Texas 2D BLE Analysis QA/QC Checklist

HUC-8 Watershed Name & ID:	Salt Draw (13070004) – SLDR_004
HUC-10 Watershed Name & ID:	N/A
Modeler:	AtkinsRealis
Reviewer:	Halff Associates

M1 Review: Terrain, Modeling and Preliminary Tie-In Review (QC Items 1-6)

M2 Review: Mapping and Completeness Review (QC Item 7) **submittal**

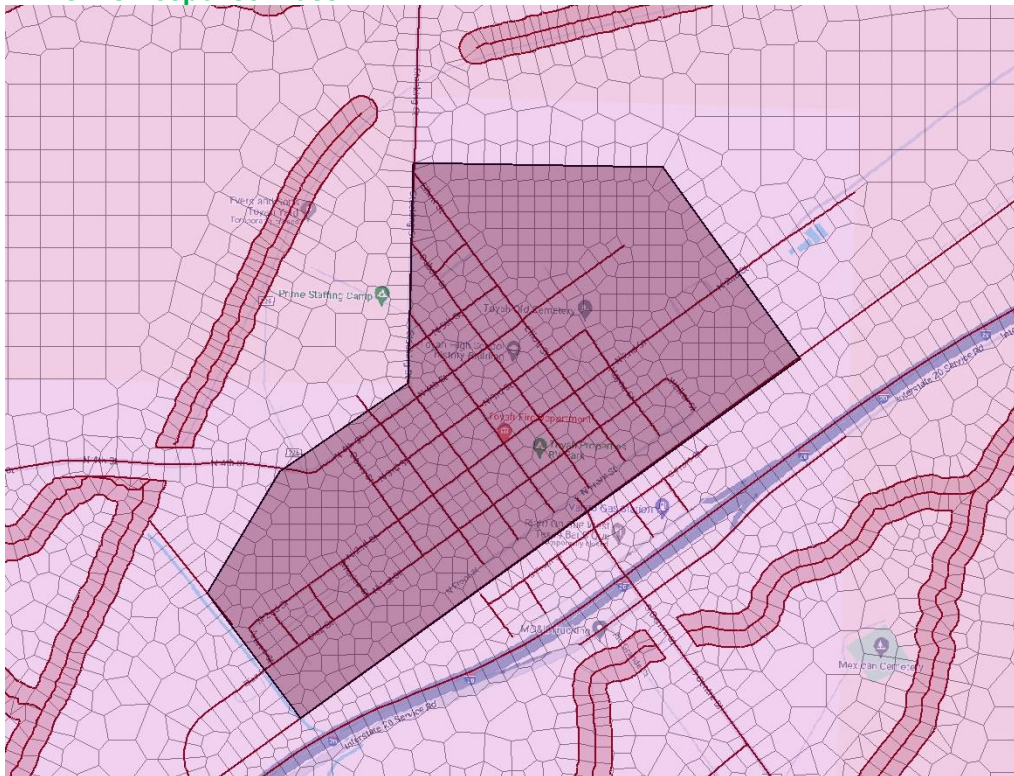
4. Please follow the TWDB naming convention as described in the TWDB 2D Guidance. The 1pct plan name differs from others.

AtkinsRealis Comment (05/22/2024): We have updated the 1% plan name. There was updated guidance on naming convention as part of H&H workshop on 01/18/2023, which shortened model naming. We have been using the updated guidance.
